Service Scope

USEFUL INFORMATION FOR USERS OF TEKTRONIX INSTRUMENTS

NUMBER 35

DECEMBER 1965

Figure 2. Waveform display showing that *Field One* is preceded by a full line of video (A) and *Field Two* by a $\frac{1}{2}$ line of video (B). (C) and (D) indicate the equalizer pulses in the vertical blanking interval that determine correct instrument triggering.

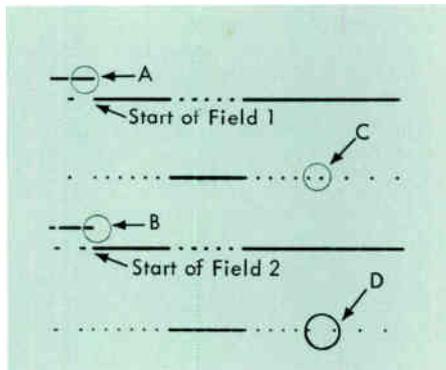
Early Type RM529 Waveform Monitors, sn's 101-399, use the terms *ODD* and *EVEN* to designate the two positions of the *FIELD* *SHIFT* switch. Subsequent to the introduction of the Type RM529, the Federal Communications Commission

(FCC) chose to designate these fields as *Field One* and *Field Two*. This new system of designating the fields may be related to the *ODD* and *EVEN* terminology as follows: *Field Two* corresponds to the *ODD* position and *Field One* corresponds to the *EVEN* position of the *FIELD* *SHIFT* switch on the early Type RM529 instruments.

Beginning with serial number 400 in the Type RM529 we changed the front panel terminology. The designation for the *FIELD* *SHIFT* switch became *FIELD* and the two positions of this switch were relabeled to conform to the FCC's designation for fields of *ONE* and *TWO*.

Figure 4. Before and After schematics showing installation of 0.1 discop in the +135 V supply of the Type 125.

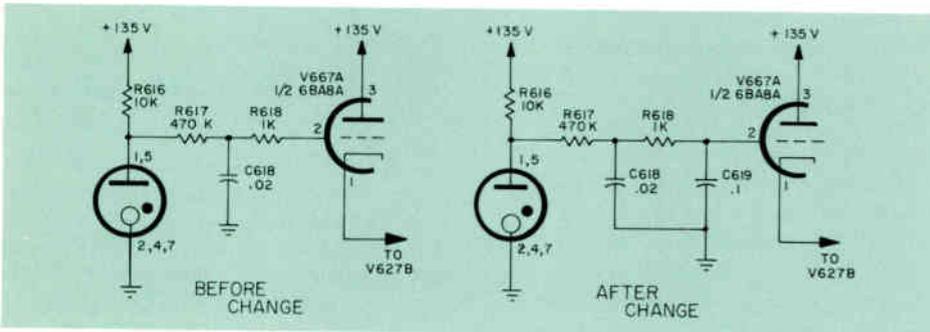
In some Type 125 Power Supplies, ripple on the +135 V supply may exceed specifications (3 mV max). This is generally due to stray pick-up at the grid of V667A, one half of a Type 6BA8A tube that forms half a comparator circuit (V6278 and its circuitry form the other half). The solution to the problem is the addition of an 0.1 mFd, 200 V discop (Tektronix part

number 283-0057-00) from the grid, pin 2, of V667A to the ground lug of the V667 tube socket. See Figure 4.

Designate the new capacitor C619 and add it to the parts list and schematic in your Type 125 Instruction Manual.

This modification is applicable to Type 125 Power Supplies, serial numbers 101-2169.
